Docket Nos. 50-269/270/287 JUN 2 0 1976

The Commission has issued the enclosed Amendments Nos. 2 2, 1 7, and 2 3 for Licenses Nos. DPR-38, DPR-47, and DPR-55 for the Oconee Nuclear Station, Units Nos. 1, 2, and 3. These amendments consist of changes to the Technical Specifications and are in response to your requests dated February 25, 1975, as revised May 7, 1976, and dated June 11, 1976.

ATTACHMENT TO LICENSE AMENDMENTS

Revise Appendix A as follows:

OPERATIONAL POWER IMBALANCE
ENVELOPE FOR OPERATION
FROM 0 TO 150±10 EFPD
UNIT 2
OCONEE NUCLEAR STATION
FIGURE 3.5.2-3B1

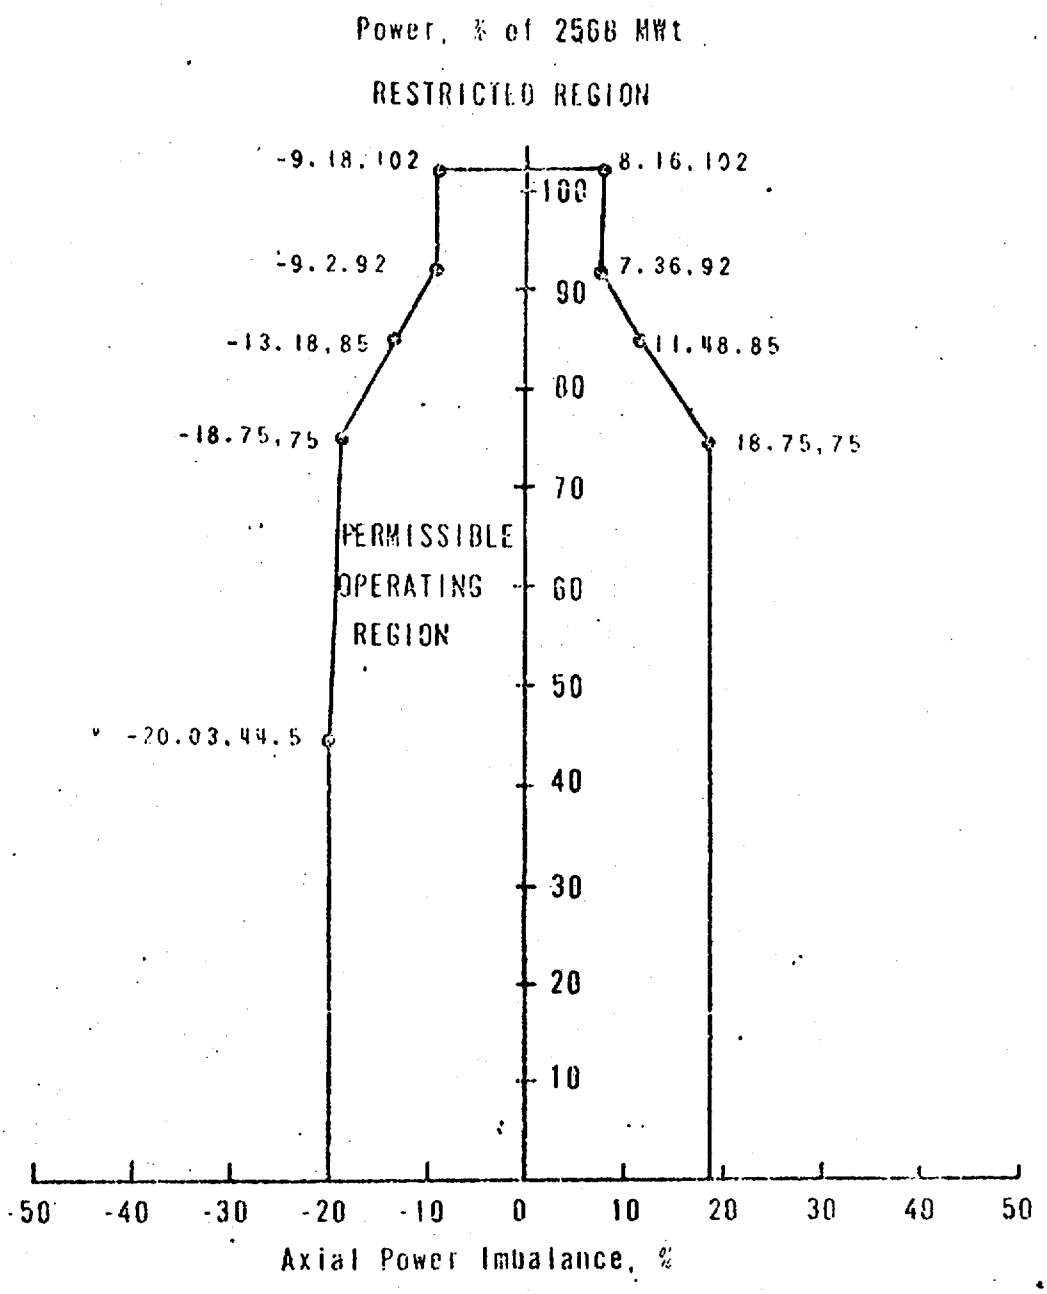
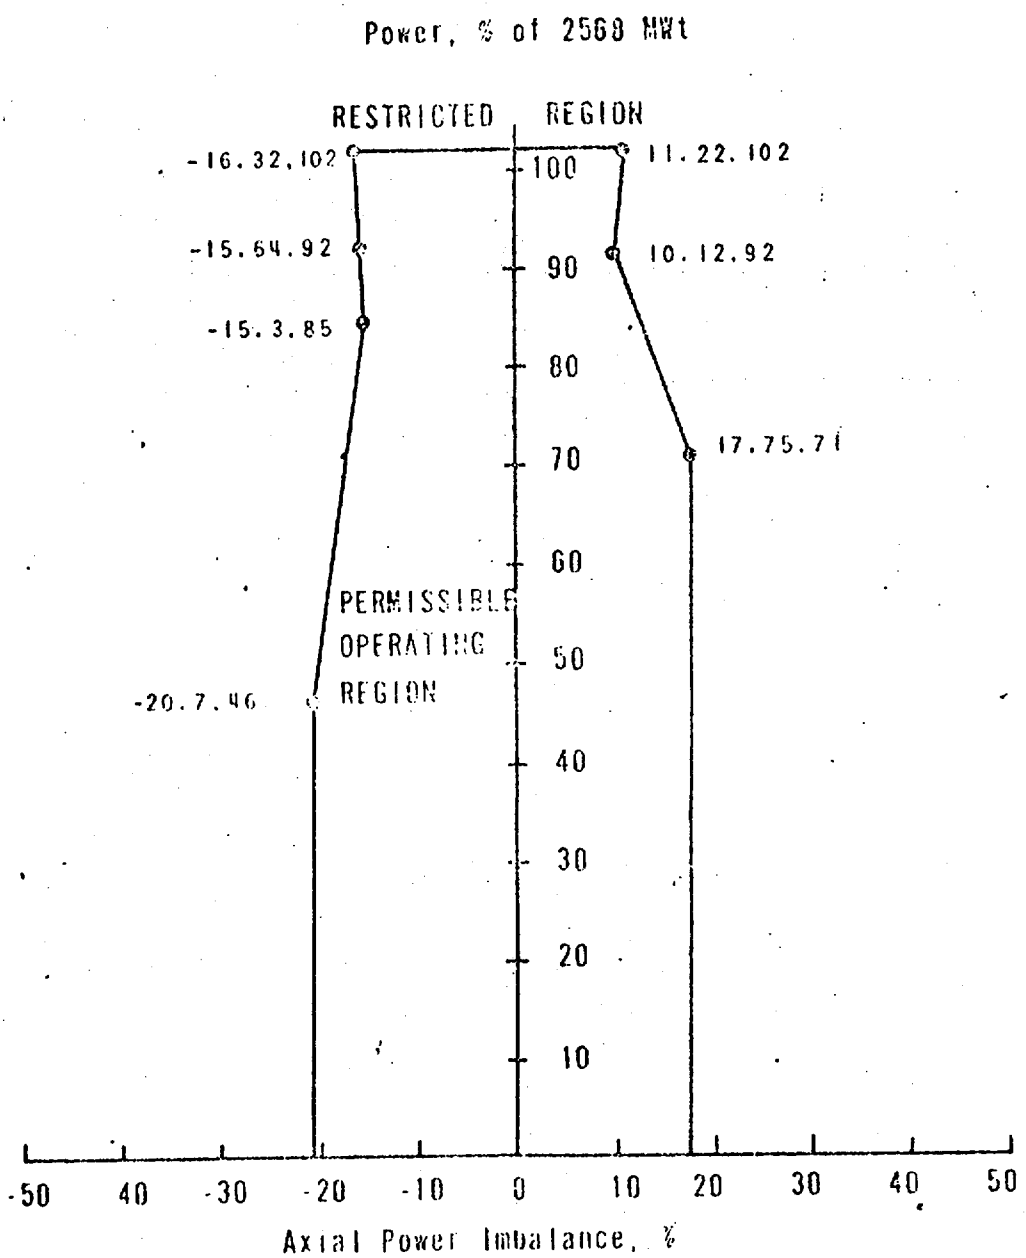
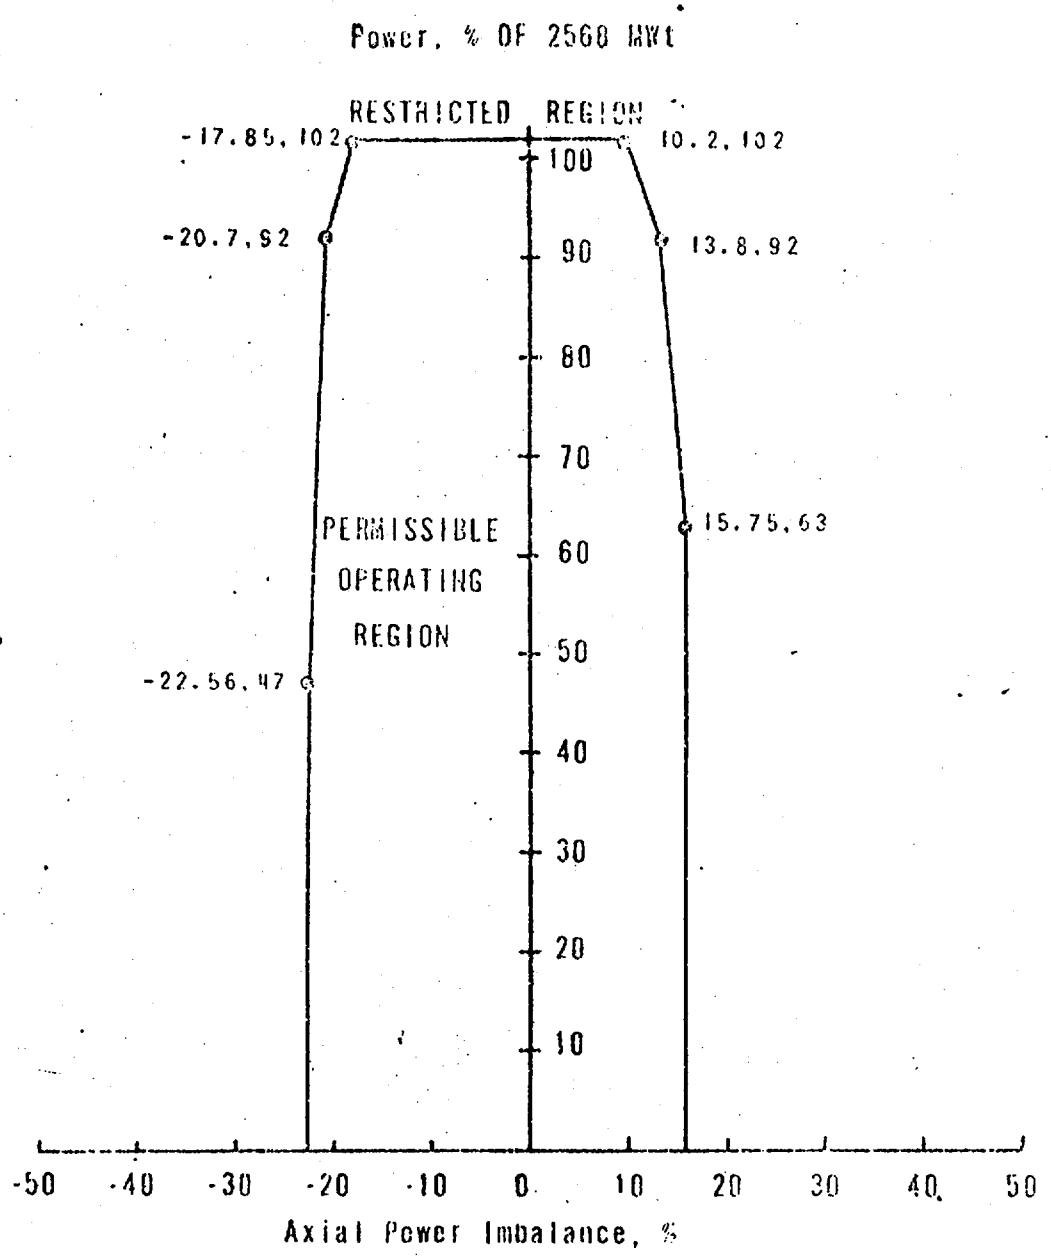
3.5.2.6 Reactor power imbalance shall be monitored on a frequency not to exceed two hours during power operation above 40 percent rated power. Except for physics tests, imbalance shall be maintained within the envelope defined by Figures 3.5.2-3A1, 3.5.2-3A2, 3.5.2-3B1, 3.5.2-3B2, 3.5.2-3B3, and 3.5.2-3C. If the imbalance is not within the envelope defined by Figure 3.5.2-3A1, 3.5.2-3A2, 3.5.2-3B1, 3.5.2-3B2, 3.5.2-3B3, and 3.5.2-3C, corrective measures shall be taken to achieve an acceptable imbalance. If an acceptable imbalance is not achieved within two hours, reactor power shall be reduced until imbalance limits are met.

The power-imbalance envelope defined in Figures 3.5.2-3A1, 3.5.2-3A2, 3.5.2-3B1, 3.5.2-3B2, 3.5.2-3B3, and 3.5.2-3C is based on LOCA analyses which have defined the maximum linear heat rate (see Figure 3.5-2-4) such that the maximum clad temperature will not exceed the Final Acceptance Criteria. Corrective measures will be taken immediately should the indicated quadrant tilt, rod position, or imbalance be outside their specified boundary. Operation in a situation that would cause the Final Acceptance Criteria to be approached should a LOCA occur is highly improbable because all of the power distribution parameters (quadrant tilt, rod position, and imbalance) must be at their limits while simultaneously all other engineering and uncertainty factors are also at their limits.** Conservatism is introduced by application of:
